TOWN COUNCIL REGULAR MEETING

Change Order No.

Date of Issuance: 9/22/2025
Owner: Town of Bristol
Contractor: Phoenix Fabricators, LLC
Engineer: Jones Petrie Rafinski Corp.
Project: Town of Bristol Water System Improvements

Bristol Water Improvements Contract B
Change Order 1
September 22, 2025

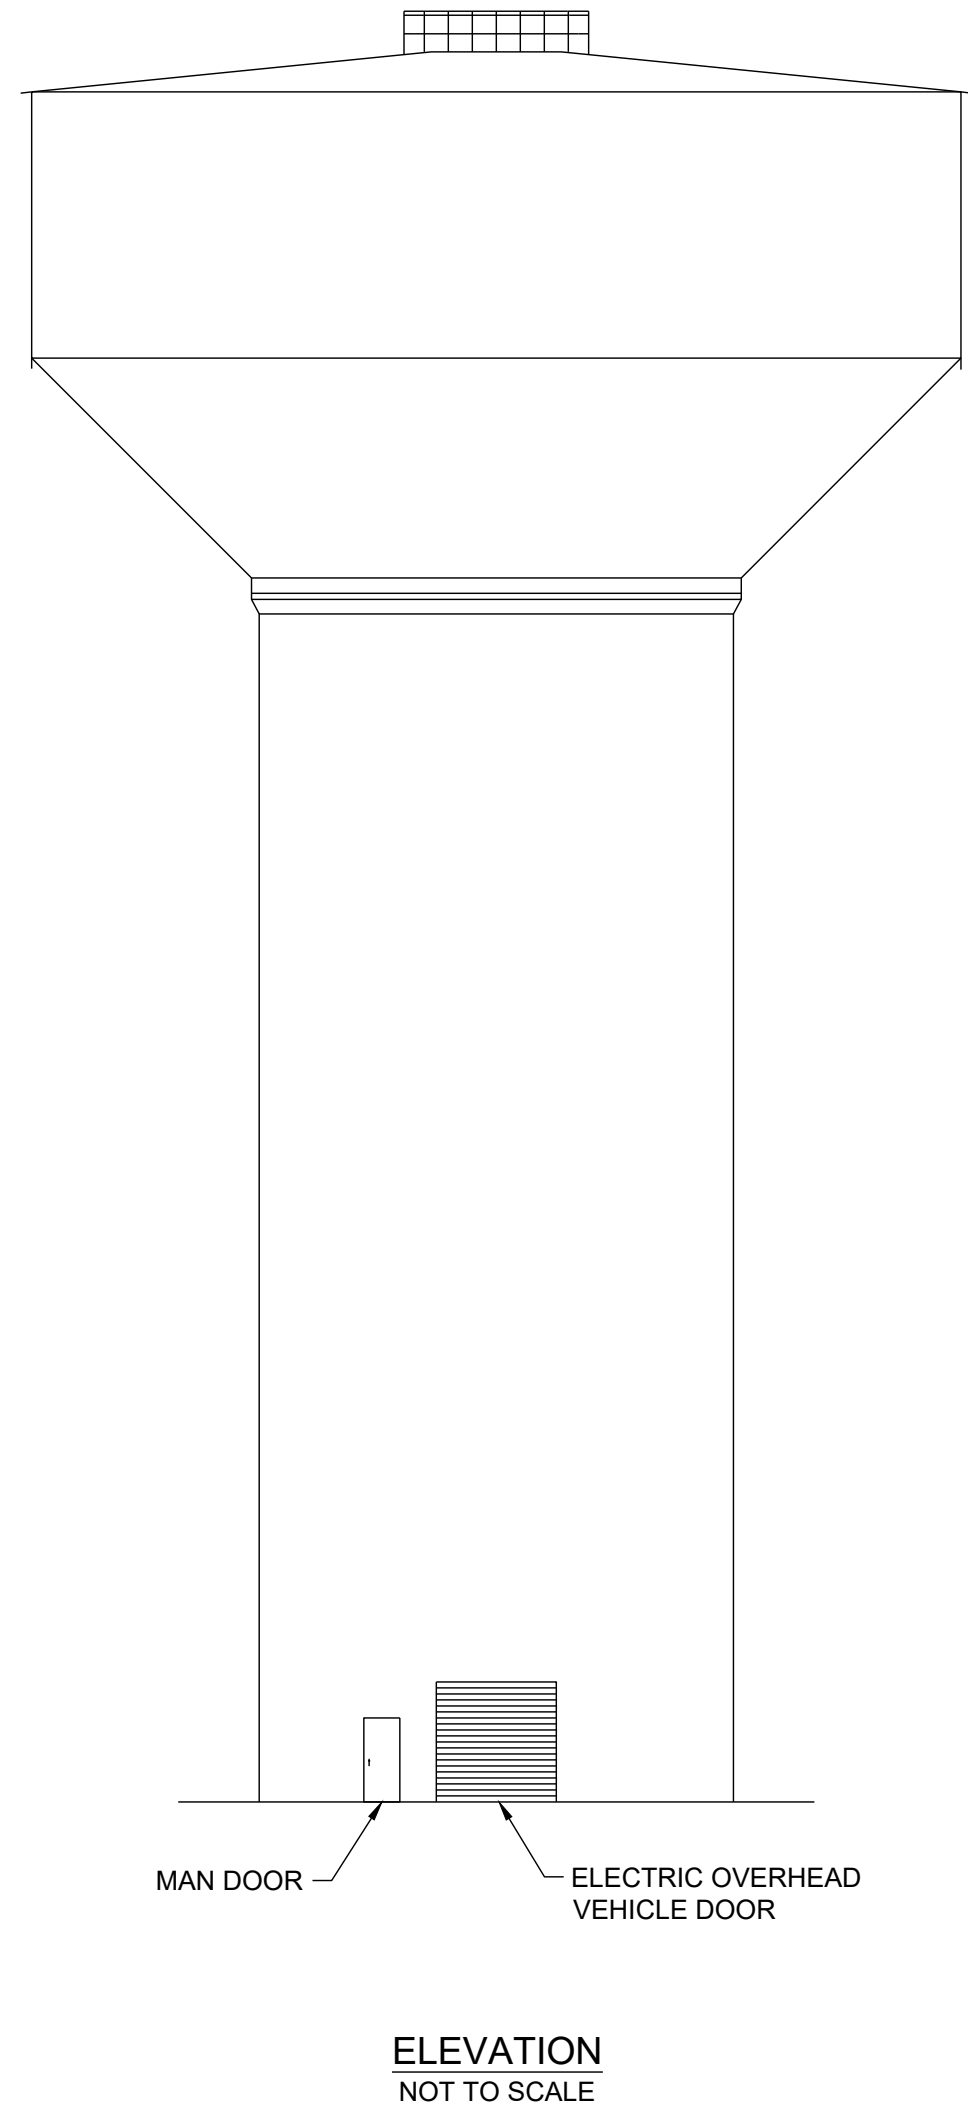
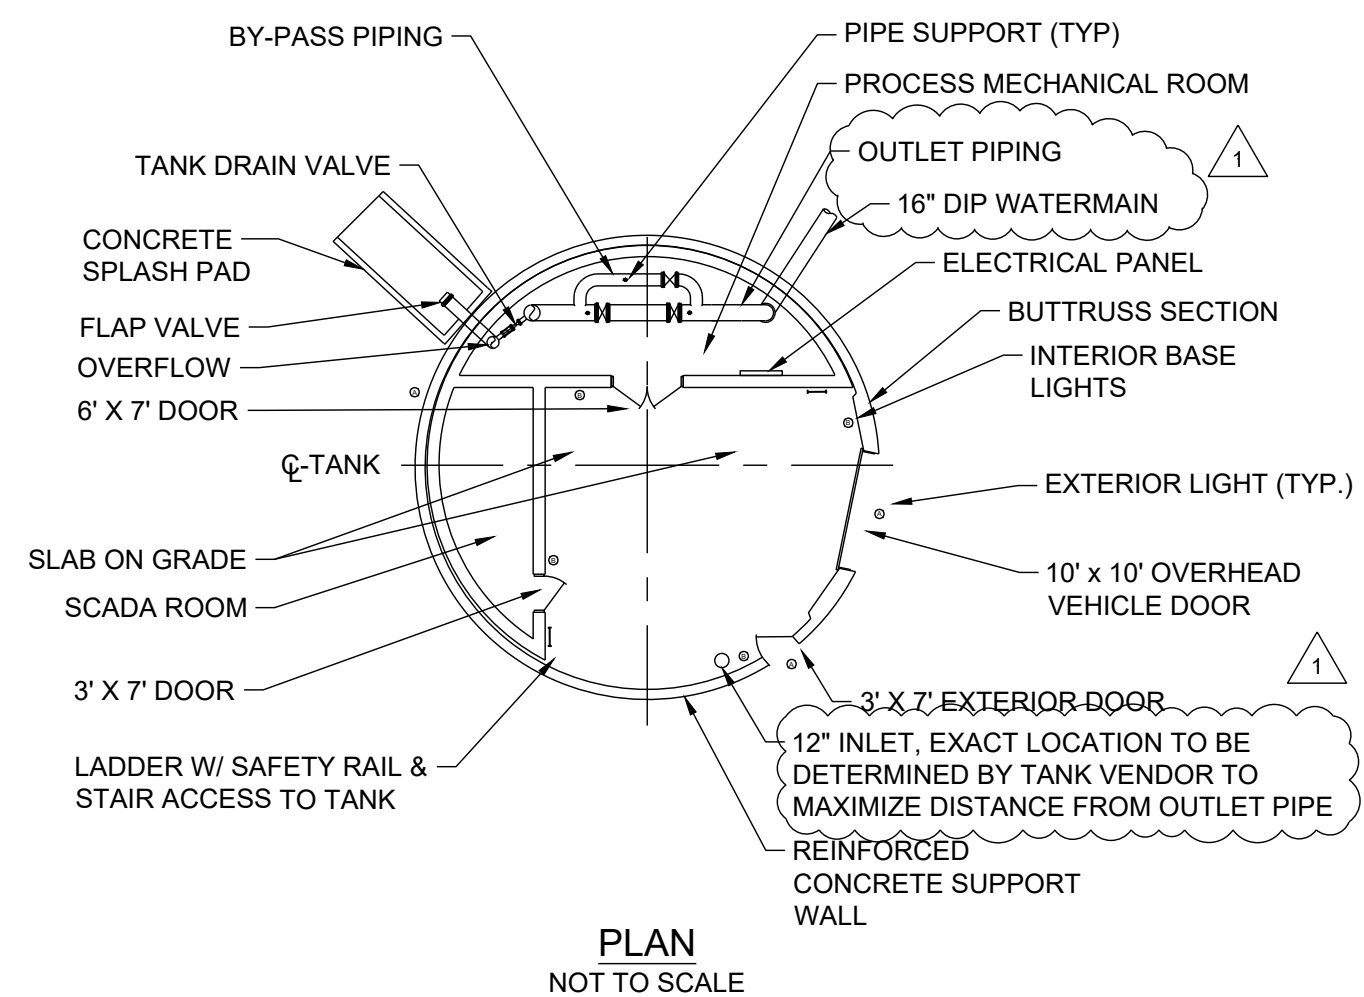
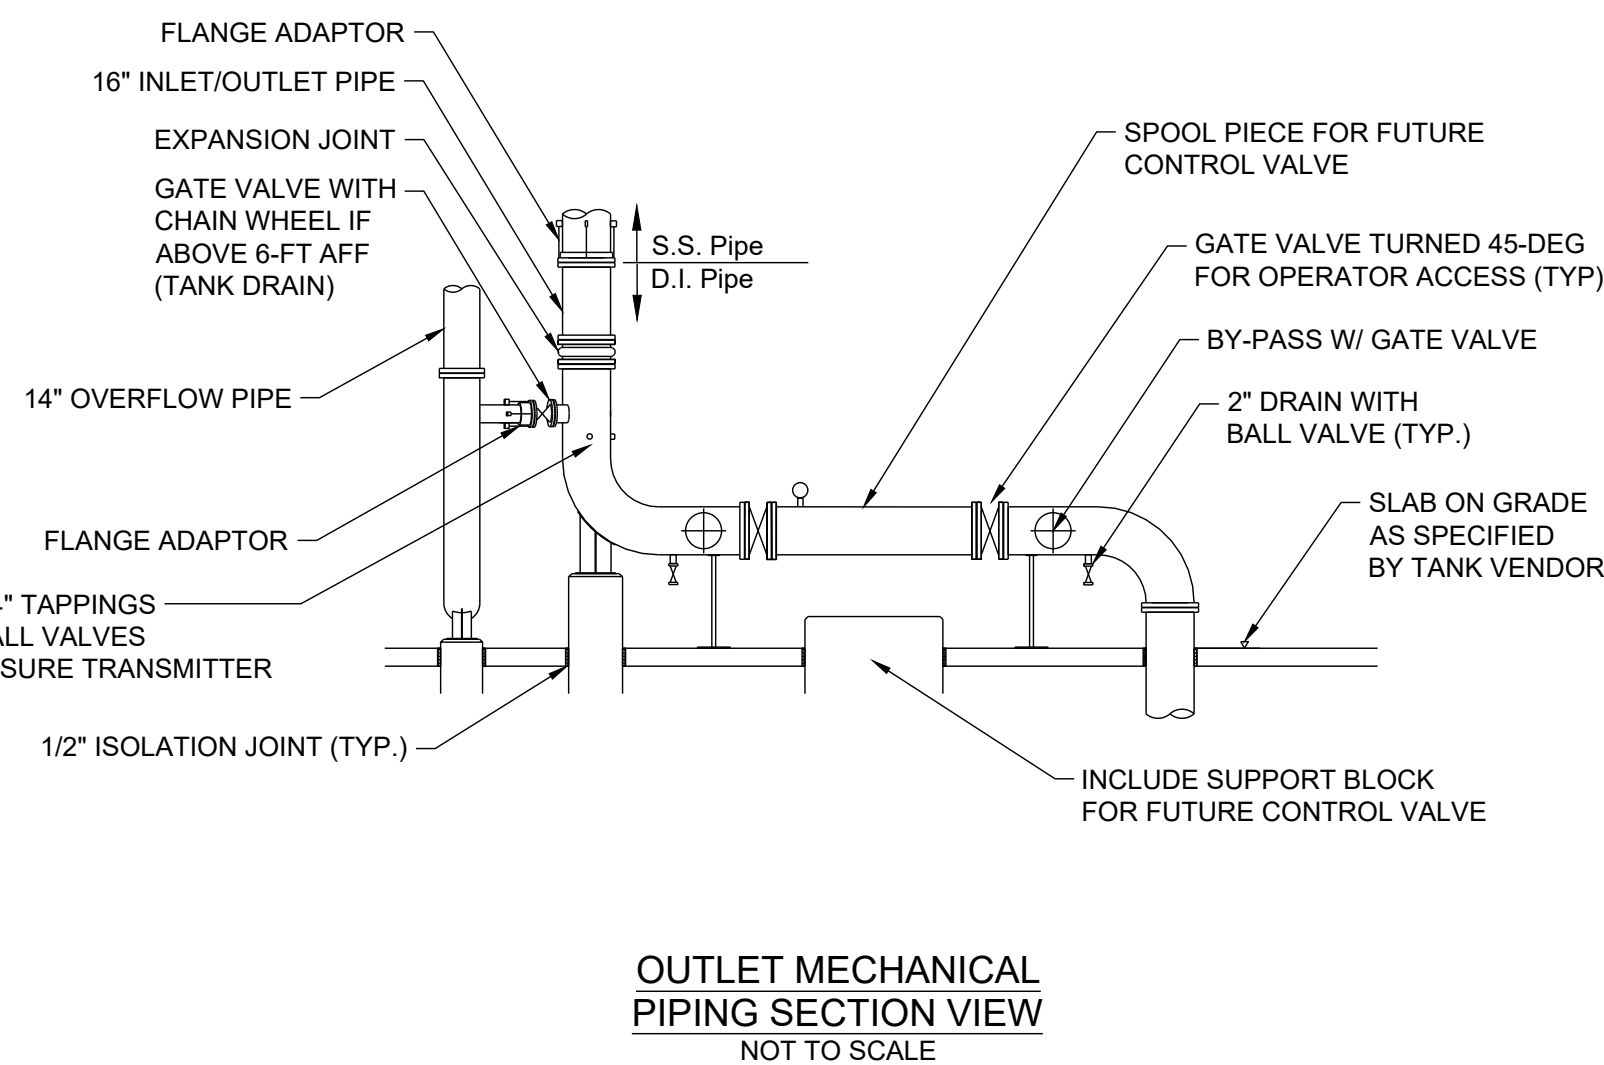
Add: Line B on C103A, M102
